Cooley Reservoir-Fulton M-1999-034 AR3 Inspection

MINERALS PROGRAM INSPECTION REPORT
PHONE: (303) 866-3567

MINE NAME: Cooley Reservoir & Fulton Wildlife Area	MINE/PROSPECTING ID#: M-1999-034	MINERAL: Sand and gravel	COUNTY: Adams
INSPECTION TYPE: Surety Release Inspection	WEATHER: Cloudy	INSP. DATE: October 30, 2024	INSP. TIME: 10:00
OPERATOR: Holcim - WCR, Inc.	OPERATOR REPRESENTATIVE: Wyatt Webster	TYPE OF OPERATION: 112c - Construction Regular Operation	
REASON FOR INSPECTION: Surety Release Requested	BOND CALCULATION TYPE: None	BOND AMOUNT: \$1,510,800.00	
DATE OF COMPLAINT: NA	POST INSP. CONTACTS: None	JOINT INSP. AGENCY: None	
INSPECTOR(S): Nikie Gagnon	INSPECTOR'S SIGNATURE: 	SIGNATURE DATE: November 21, 2024

This inspection was completed as part of acreage release request (AR3), submitted in accordance with Rule 4.17, received by the Division on September 18, 2024. Nikie Gagnon with the Division of Reclamation, Mining and Safety (Division/DRMS) conducted the inspection. Wyatt Webster, representing Holcim-WCR Inc. (Operator) along with Josh Redman and Jason Helms, representing the City of Thornton, accompanied the Division during the inspection.

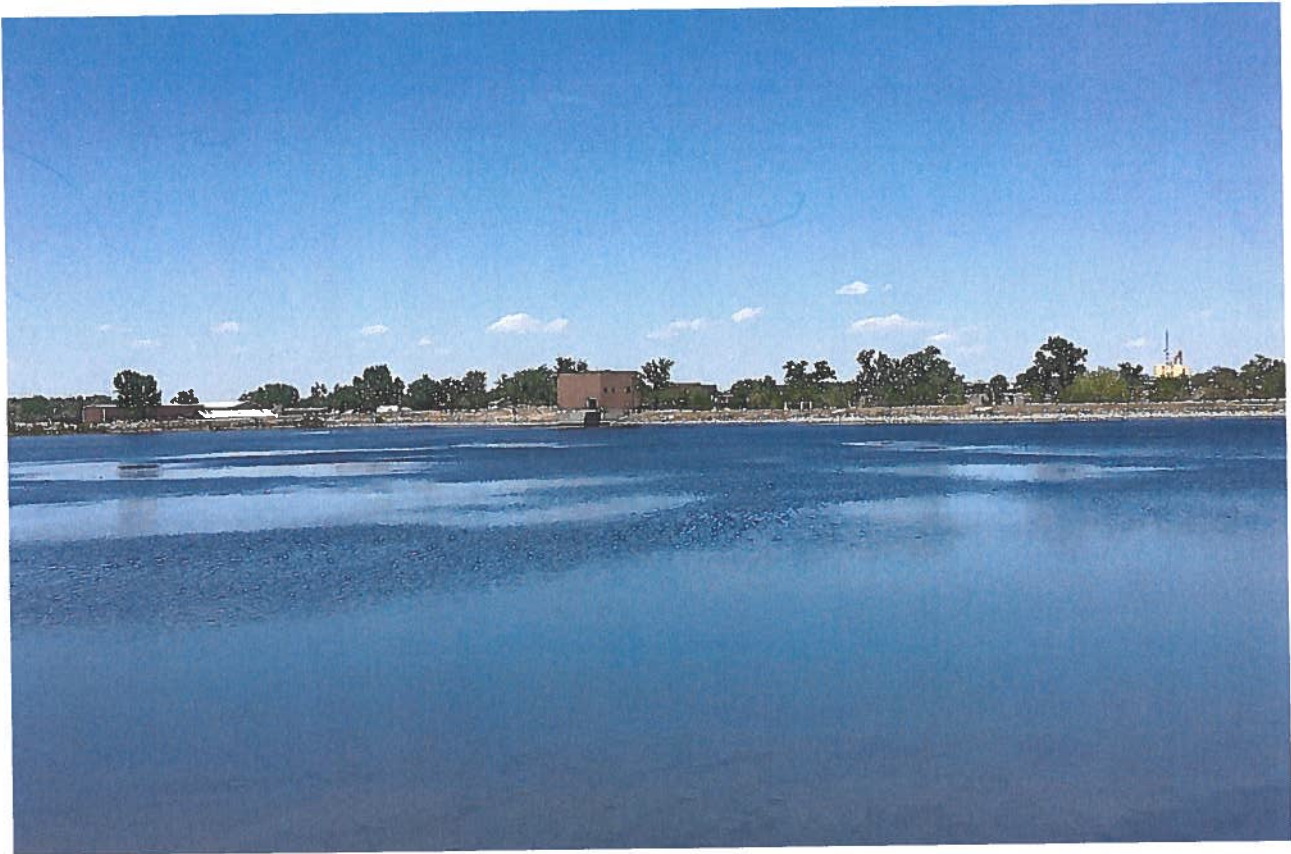
Based on observations during the inspection, the Division concurs with the 2022 Slope Assessment. The eastern shorelines of the South Cell (Photo 7) and Middle Cell (Photo 10) show signs of wave cutting and erosion and the slopes are nearly vertical in these areas. Therefore, the reservoirs do not meet the requirements of Rule 3.1.5(7) for a release. The representatives from the City indicated they are in the process of drawing down the South Cell to allow for repair of the eastern shoreline. It is anticipated to take a few years to complete all the recommended slope repairs due to the operation of the facility.

Photo 7: Looking southeast along the eastern boundary of the South Cell. Shoreline erosion observed here. 2022 Assessment rates this area as high risk.

Photo 10: Looking northeast along the eastern shoreline of the Middle Cell. Shoreline erosion observed here. 2022 Assessment rates this area as high risk.

Cooley West South Cell

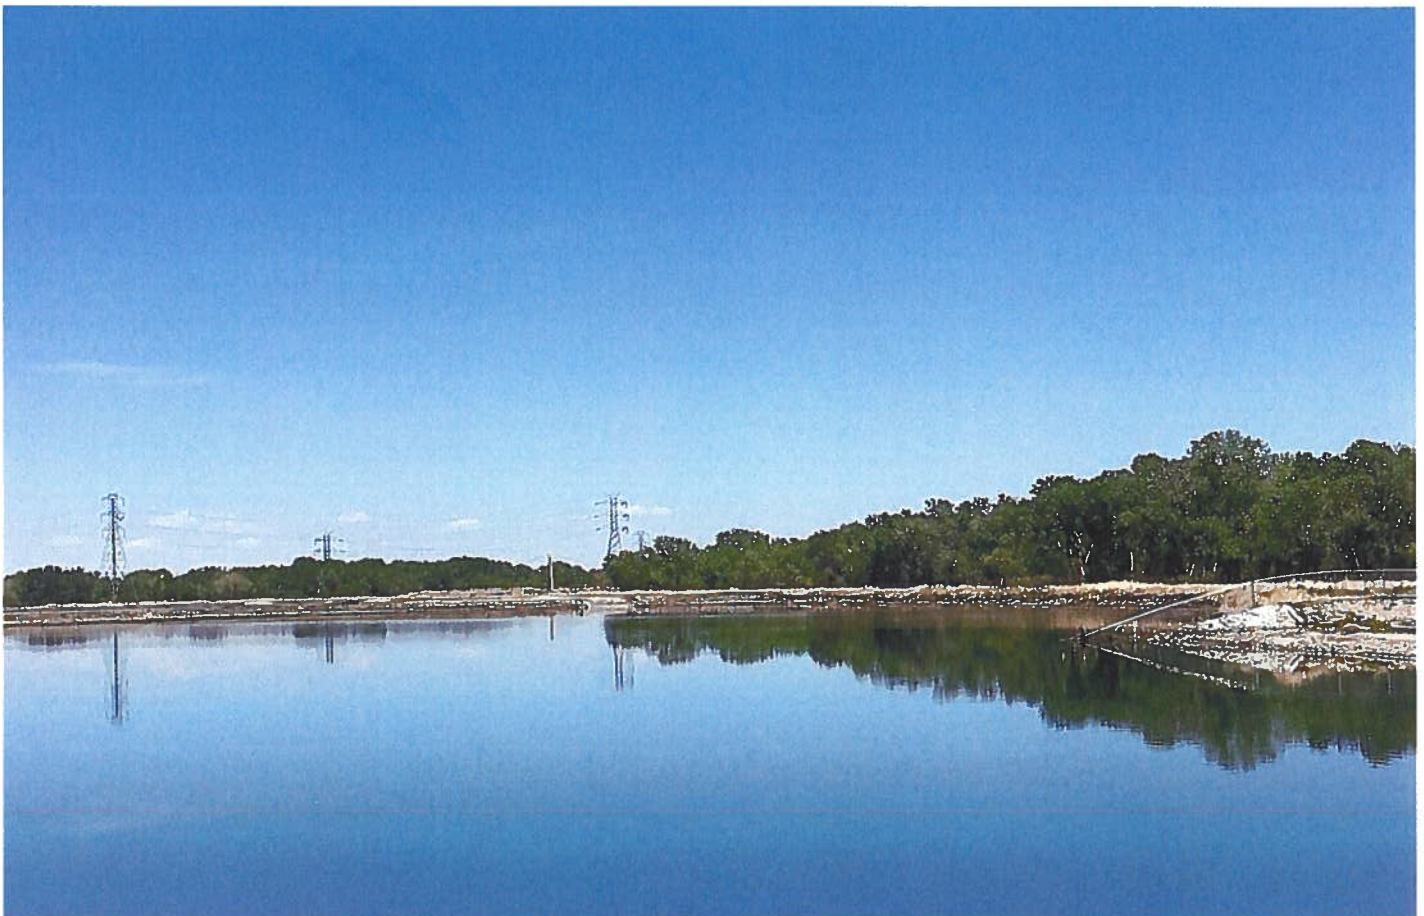
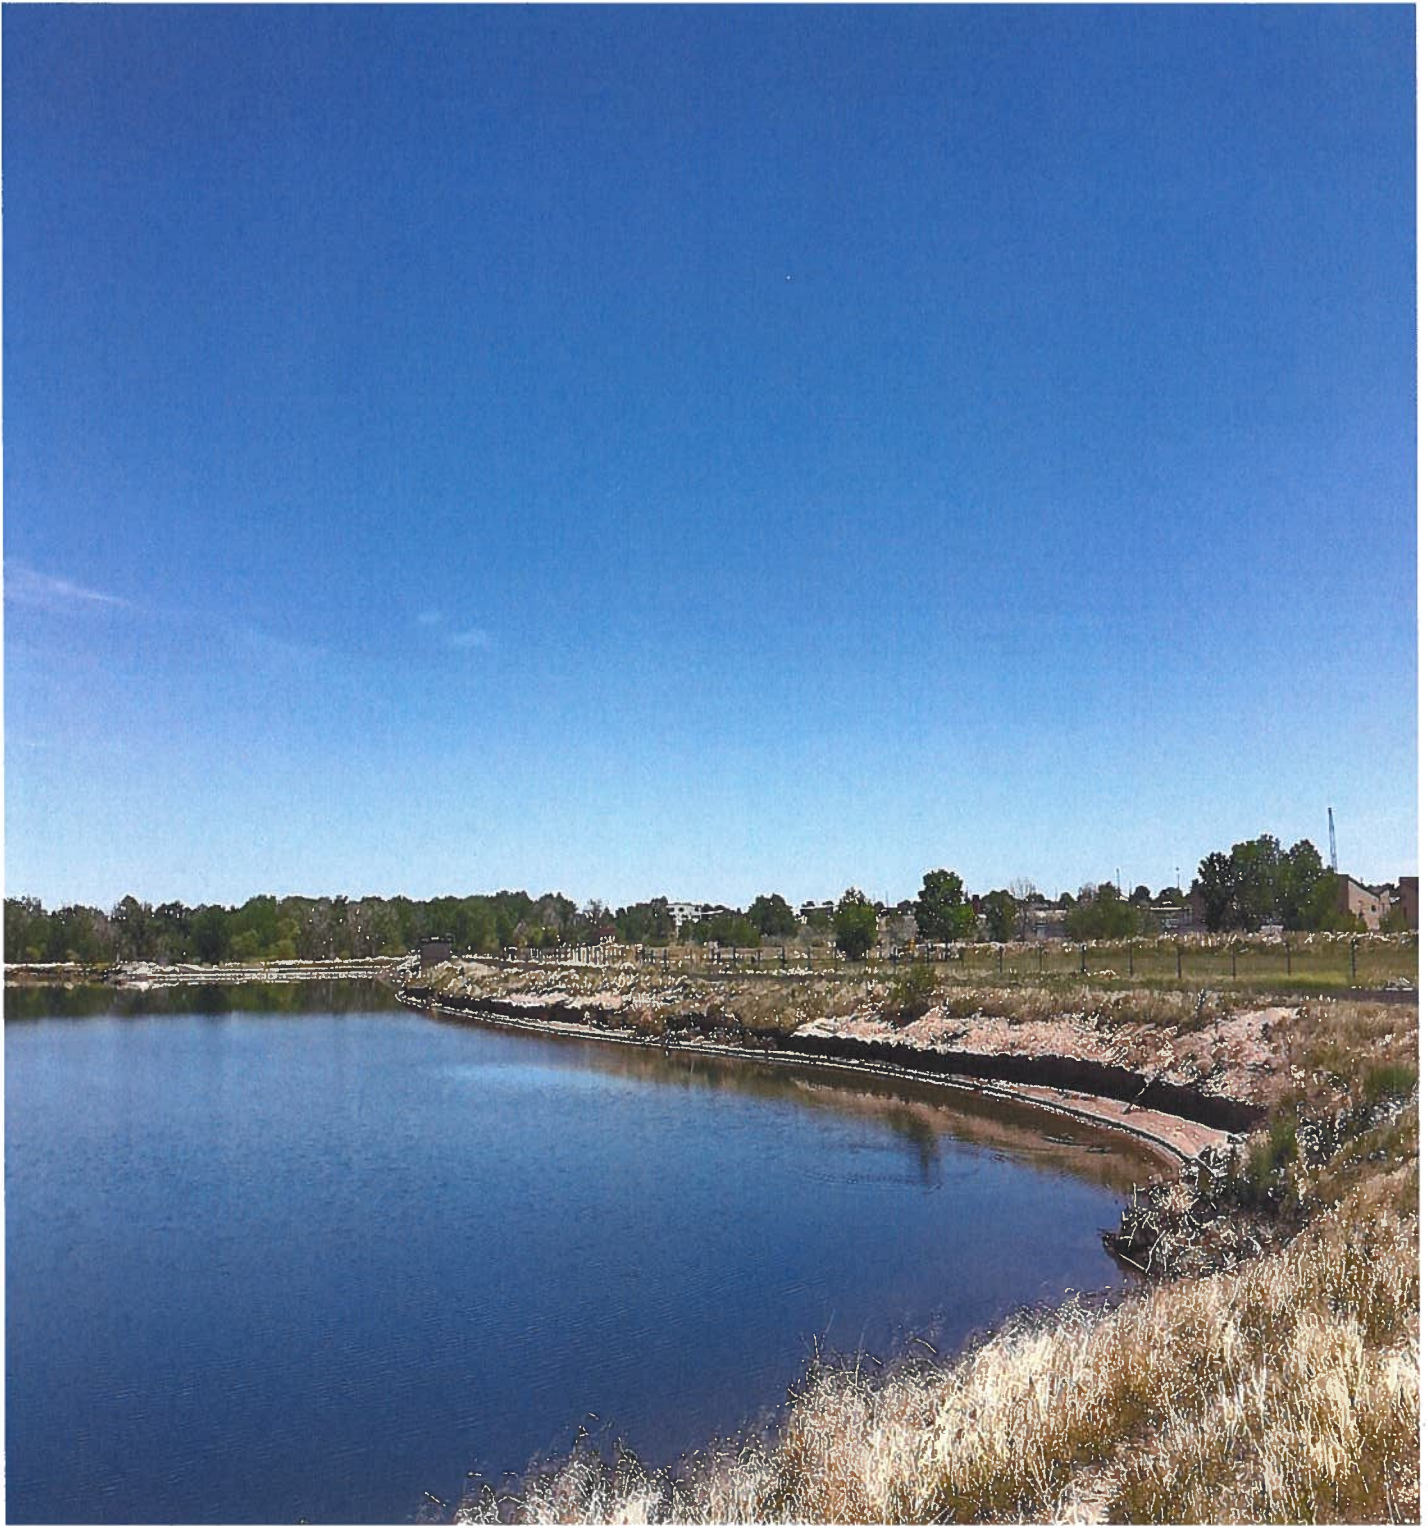
During the 2022 slope assessment, Water Resources staff observed erosion to the eastern and southern slope of South Cooley. Approximately 2,400 linear feet of shoreline was assessed as High Risk. The most noticeable areas are from Southwest to northeast, by the spillway into Middle Cooley's. The reservoir is now taking in additional flows due to common flood stages. The rivers flood risk into the reservoir is more common and effects the shoreline more often than in the past years.

- Slope Rating: 4 Low Risk (Solid green line) 1,574 feet
- Slope Rating: 3 moderate risk (solid yellow line) 1,200 feet
- Slope Rating: 2 High Risk (Solid orange line) 2,400 feet

View of south and east shoreline, erosion of banks

View of spillway section along south end and eastern shoreline, with bank erosion

View of south shoreline to spillway with bank erosion
